SECTION 4.55(2) MODIFICATION APPLICATION CROWN SYDNEY HOTEL RESORT (SSD 6957)

This application has been prepared by Ethos Urban on behalf of Crown Sydney Hotel Resort (Crown) pursuant to section 4.55(2) of the *Environmental Planning and Assessment Act 1979* (EP&A Act) to modify Development Consent SSD 6957 (**Development Consent**) relating to the approved Crown Sydney Hotel Resort located at 51a Hickson Road, Barangaroo, NSW.

Figure 1 Changes to Level 3 restaurant terrace

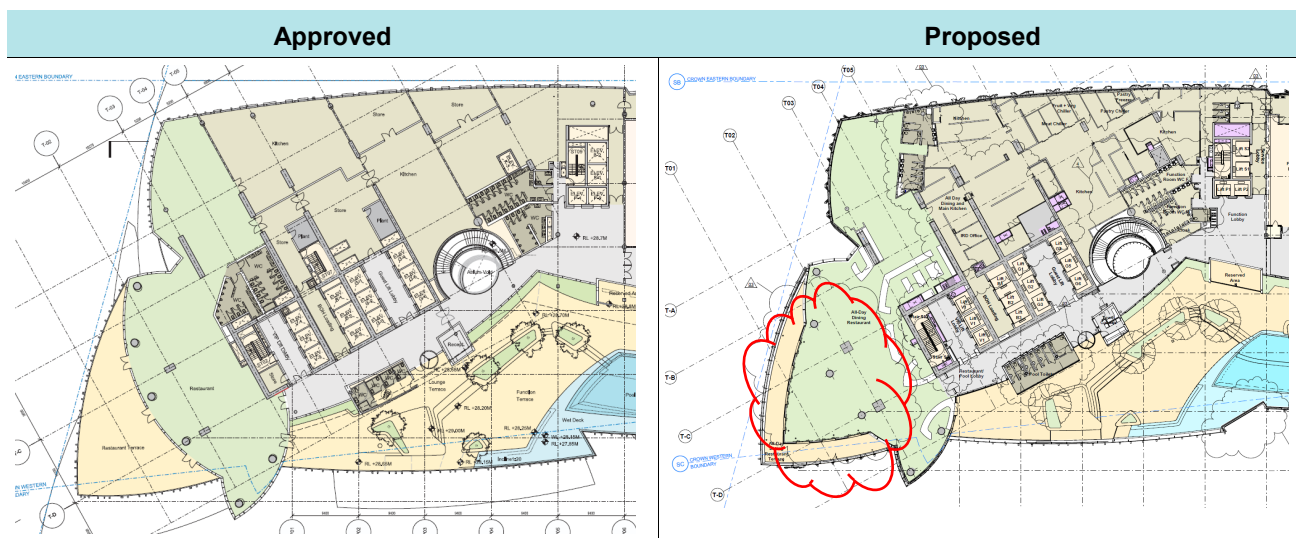
The proposed modification to the All-Day Dining Area on Level 3 involves the relocation of the exterior glass wall of the restaurant to enclose a greater portion of the exterior terrace which results in a proposed change from outdoor to indoor use. It is important to note that the originally approved glass oversail and stone veil, which is the primary building facade in this location, remains unchanged. This reduction in outdoor terrace area and the inclusion of outdoor seating into the building has been proposed as it will help to deliver an improved dining environment for customers, whilst at the same time deliver a reduction in environmental impact due to the decrease in outdoor seating and subsequent reduction in noise impacts. See Operational Noise Statement at **Attachment J** for further details.

Figure 2 Changes to Level 4 spa terrace

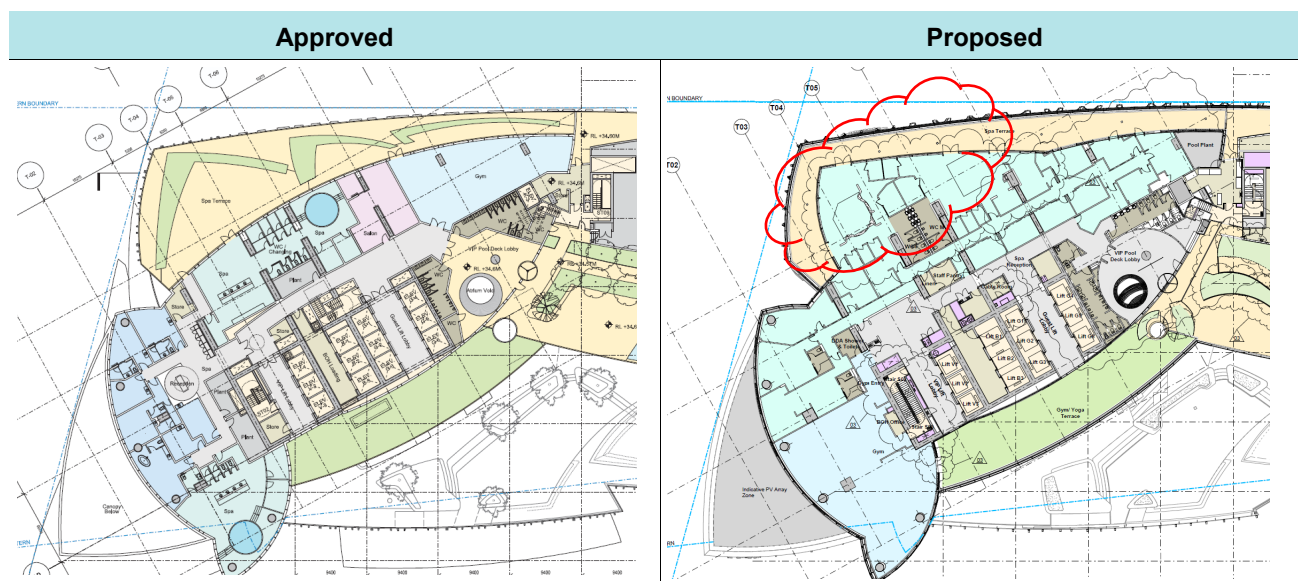
The proposed modification to the Spa area on Level 4 involves the partial enclosure of the eastern facing terrace area as shown in **Figure 4** and the Architectural Plans provided at **Attachment A**. The change allows for the creation of some additional areas and rooms to be used for the relaxation spa.

The proposed change as shown in **Figure 4** reflect the new enclosed area which will sit behind the glass oversail and stone veil that wraps around the podium structure which defines the building's external façade. It will therefore remain largely screened from view when at ground level and will further deliver a reduction in environmental impact due to the decrease in outdoor seating and subsequent reduced external noise impacts, see **Attachment J**.

Figure 4 Changes to Level 24 hotel terrace

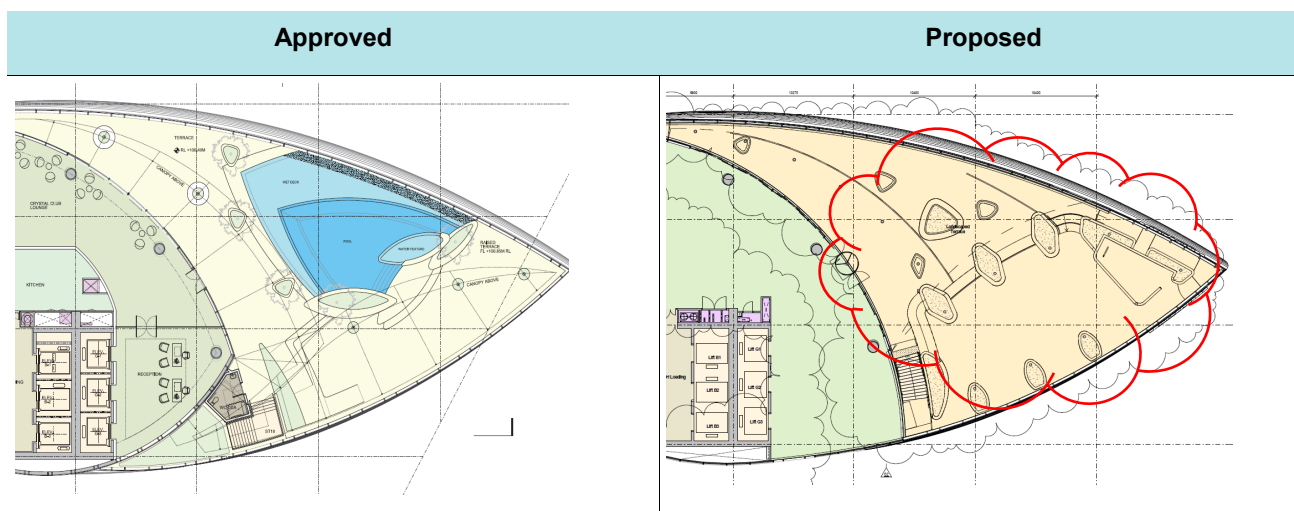
The pool has been removed as part of the updated landscape design for the terrace. The approved pool on Level 24 was largely decorative in nature and to be used by a small number of hotel patrons only, and therefore relates only to modifications of the facilities available to these patrons. The terrace is now proposed to remain landscaped, with the exclusion of the pool on Level 24, and no changes to the building façade will be evident when viewed externally. Alternative pools remain available for hotel patrons on Levels 3 and 4. The proposed removal of the Level 24 pool is minor in the context of the whole development and does not affect the functionality of the building or give rise to any new or additional environmental impacts.

Figure 6 View of proposed window Extract of proposed east elevation

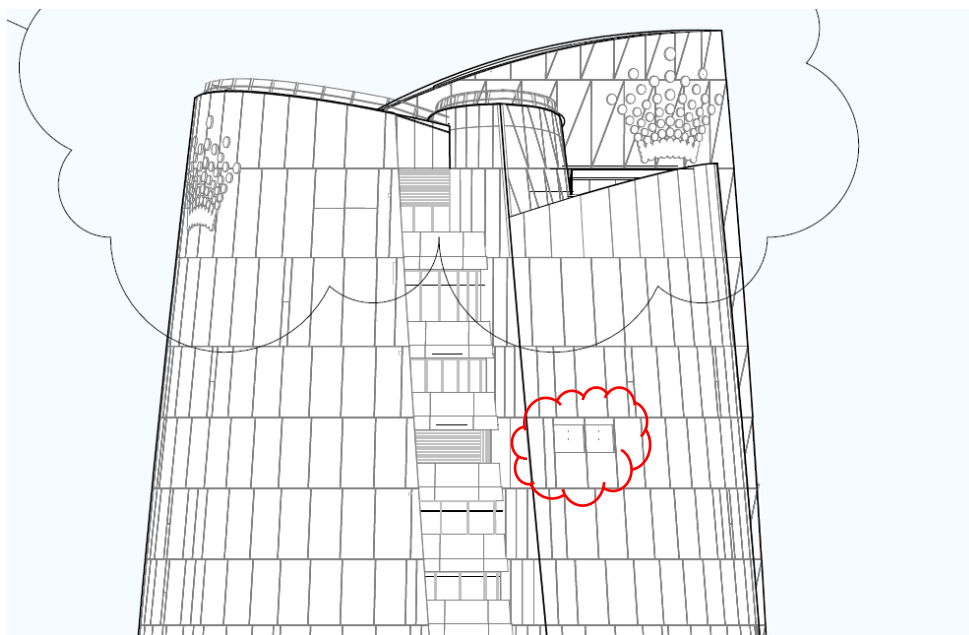
An observation deck has been included on level 66. Inclusion of the observation deck was a requirement imposed by the Planning Assessment Commission in its determination of the original application (SSDA 6957). The requirement was imposed via Condition B6 of the development, which required the inclusion of a publicly accessible observation deck to allow for views over the Sydney harbour. Inclusion of the observation deck has been achieved with only minor modifications to the building's external façade, with the insertion of one window to allow views towards the Harbour Bridge and the Sydney Opera House (see **Figure 5** and **Figure 6**).

In addition, minor façade vision glass/spandrel panel coordination modification is proposed, to correspond with the modified interior room layouts.
